Re: 87 Memorial Parkway  
Block 61, Lot 4

**Re: Zlata (PB20-18)**  
**Bulk Variance Application – Technical Review #1**  
**Location: 87 Memorial Parkway**  
**Zone: OR (Office Residential District)**  
**Block 61, Lot 4**  
**Borough of Atlantic Highlands, Monmouth County, NJ**  
**Our File: HAHP0061.02**

Erin Uriarte, Planning Board Secretary  
 Atlantic Highlands Borough Planning Board  
 Re: Zlata & Clancy (PB22-12)  
 Bulk Variance Application – Review #1

Nancy Tran, Planning Board Secretary  
 Atlantic Highlands Borough Planning Board  
 Re: Zlata & Clancy (PB22-12)  
 Bulk Variance Application – Review #2

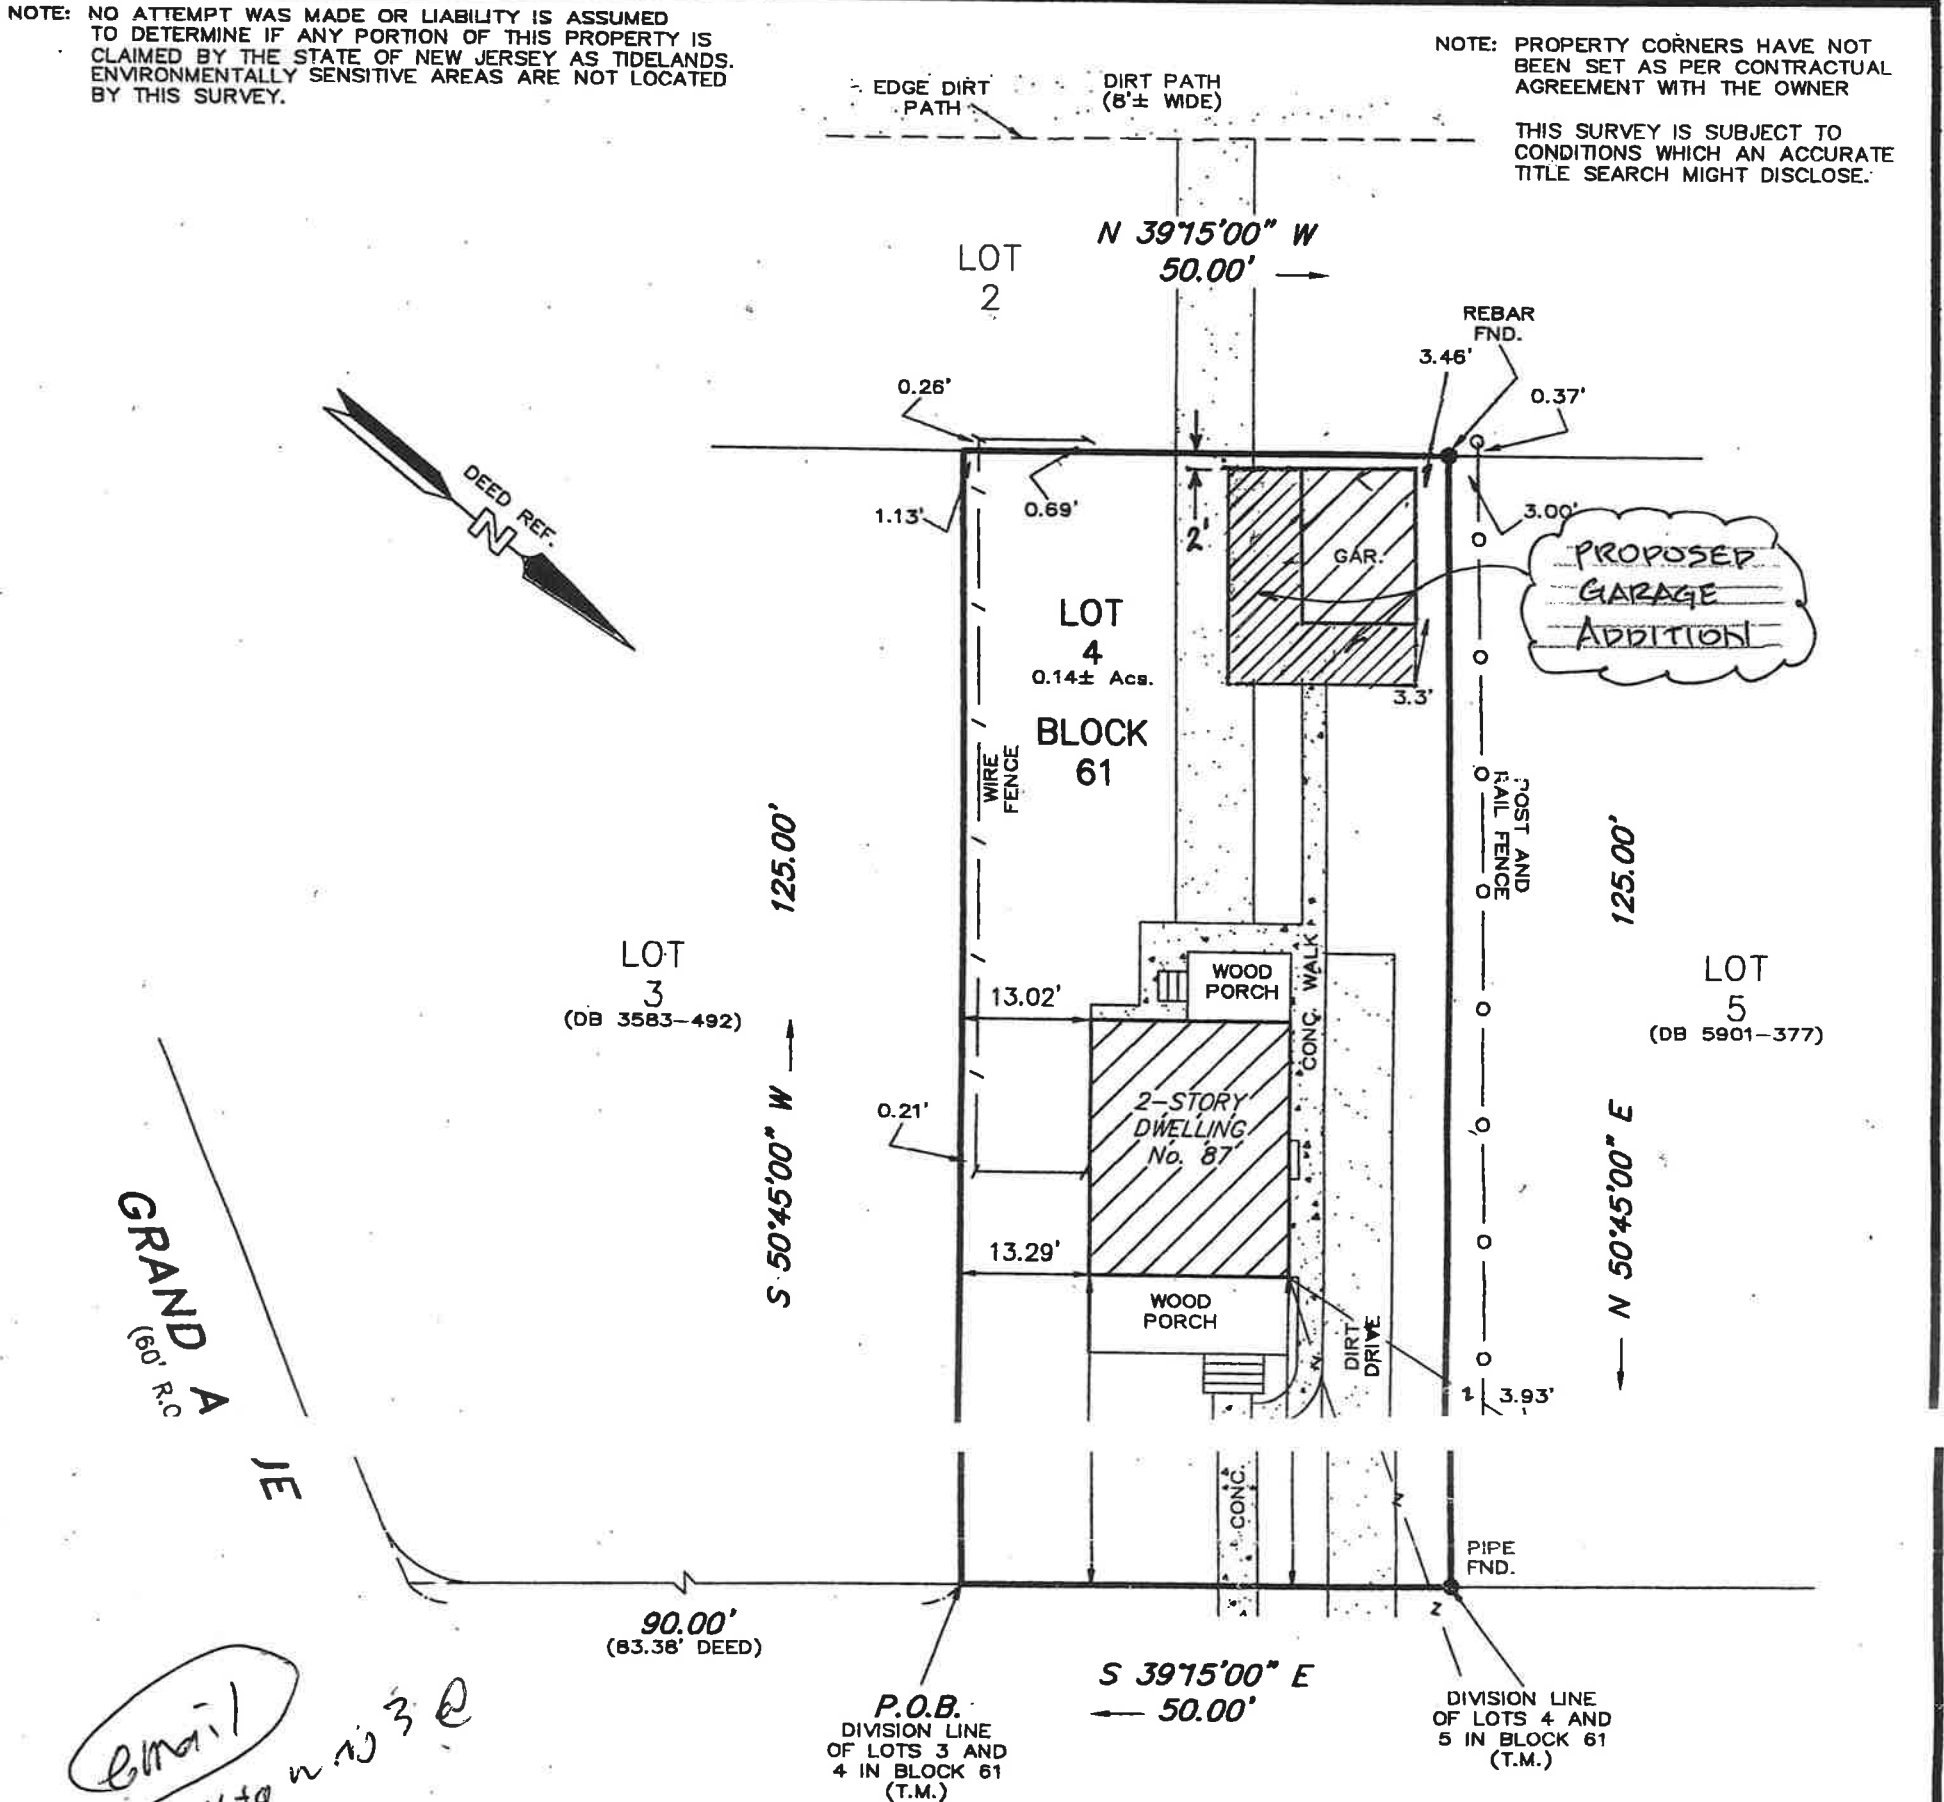
7. The following information is required to be submitted prior to the application being deemed complete for review and public hearing:
- a) Per the survey dated April 28, 2022, expansion of the structure is proposed approximately 1 foot over the rear property line on Block 61 Lot 2. The previously provided survey, dated June 6, 2000, shows a 2' setback from the rear property line. Applicant to clarify property boundaries and work location.

- b) Owner of Lot 2 must co-sign the application or otherwise formally approve the proposed encroachment.
  - c) Applicant should provide clarification for expansion of the existing garage structure in lieu of full demolition and replacement in a conforming location. Applicant to confirm which portions of the existing structure are to remain and if any clearing, driveway expansion, or other work is proposed.
  - d) The Applicant should provide site photos depicting existing conditions.
  - e) The existing principal and accessory building heights should be clarified.
8. Based upon our review of the subject application, we estimate that the following fees are required:

GARAGE RENOVATION & ADDITION

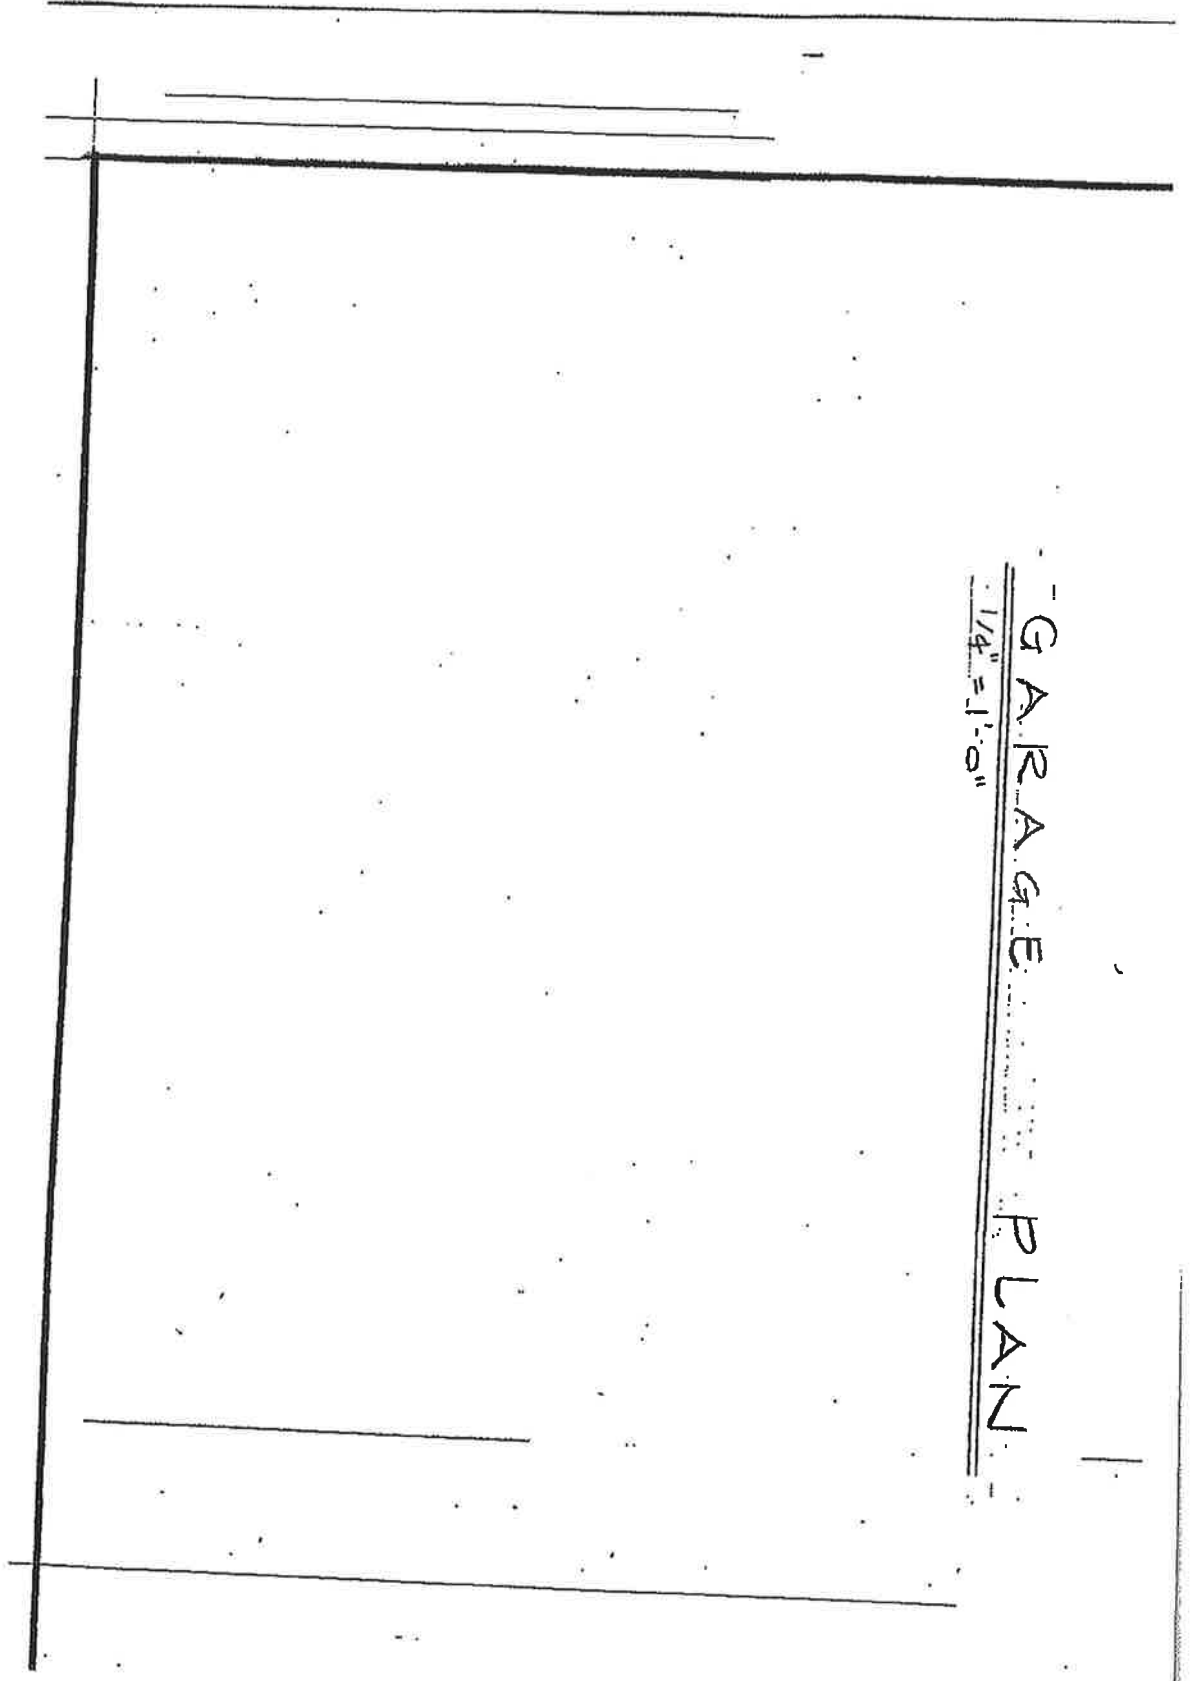
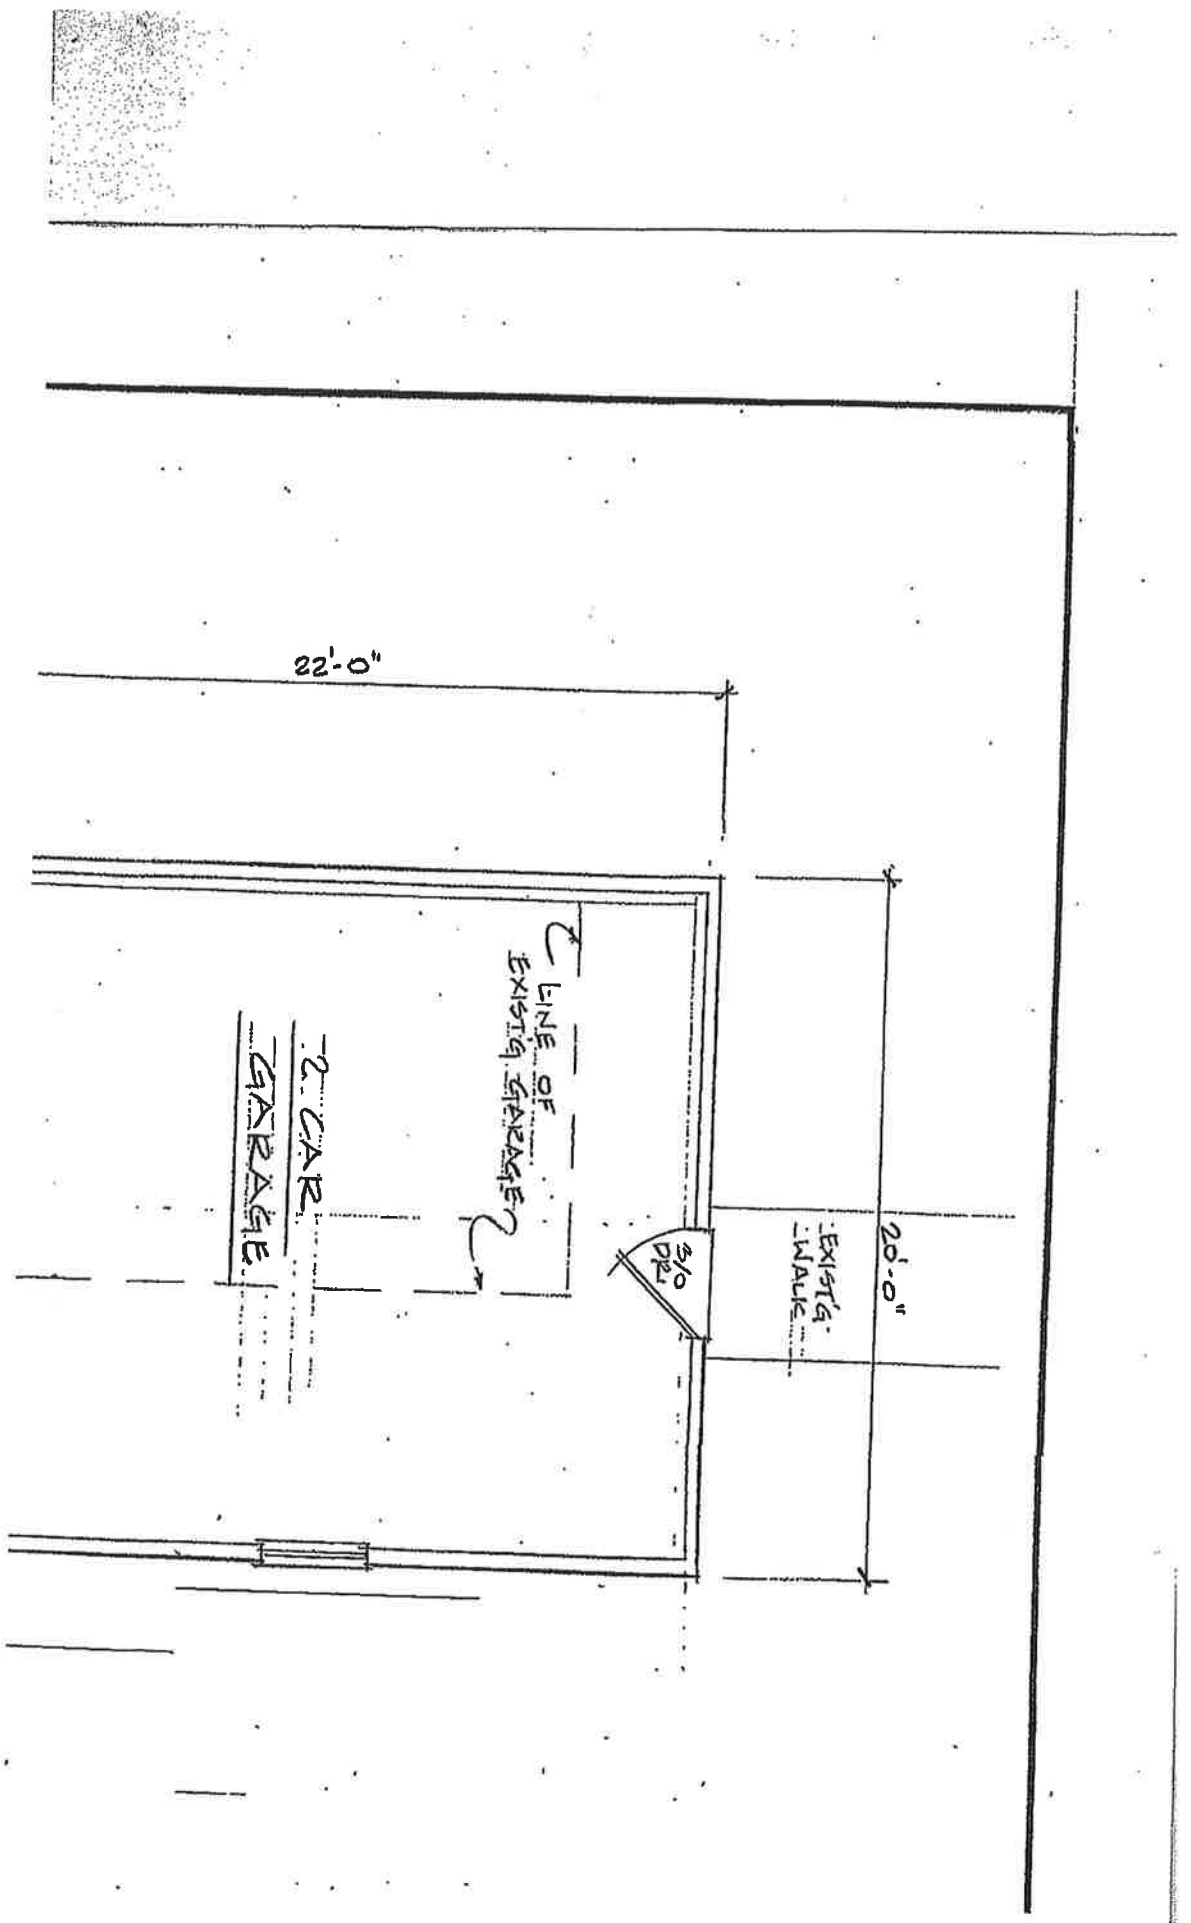
- d) **Section 150-29(A)(2)(Exhibit 5-2)** – The maximum allowable accessory building height is 16 feet, whereas 16.17 feet is proposed.
5. It appears that the following existing non-conformities would remain with respect to this Application.

- h) Applicant should discuss existing and proposed building height for the garage structure.
- i) Applicant should provide site photos depicting existing conditions.
